South Dublin County Council,
Planning Department,
County Hall, Belgard Square north,
Tallaght,
Co Dublin

**CLARIFICATION OF ADDITIONAL
INFORMATION Reg. Ref. SD22A/0126**

On behalf of our Client, First Step Homes, we wish to lodge this response to the Clarification of Additional Information request from South Dublin County Council, dated 12th August 2022. To support this Additional Information submission, we hereby include 6 No. copies of the following documentation

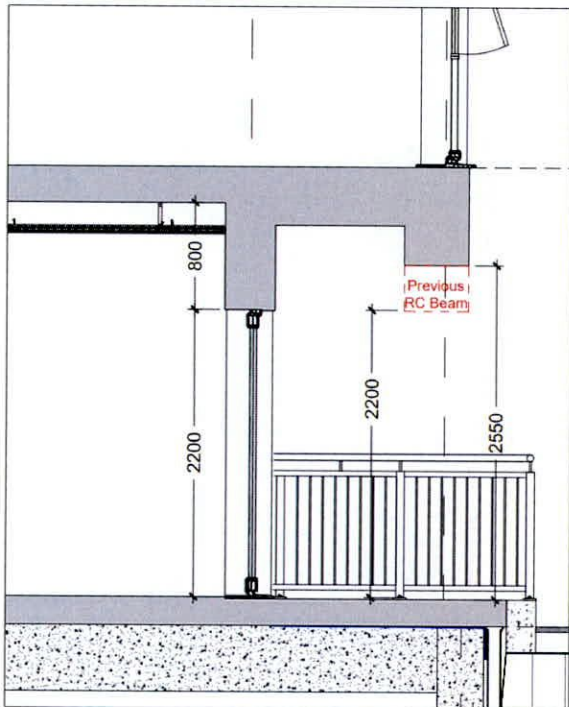
There are a number of issues with the Sunlight and Daylight Assessment report.

- The 3D model referred to in the report is not shown, and it is not clear that balconies / overhangs have been taken into account in all assessments.

The revised report includes the images of the 3D model used to conduct the simulations for the assessment. These images clearly show that the balconies / overhangs have been taken into account for the assessment.

Care has been taken when redesigning the units to improve the daylight and internal light levels of units at ground floor level. For instance, the balcony of unit 14 at first floor level and balcony of unit 27 at second floor level has been repositioned to avoid unit 2 at ground floor level to be under an overhang. In addition, the edge beam of the overhang at first floor level has been reduced to allow for increased sunlight and daylight along with improved sky exposure to the ground floor units. Please see image below.
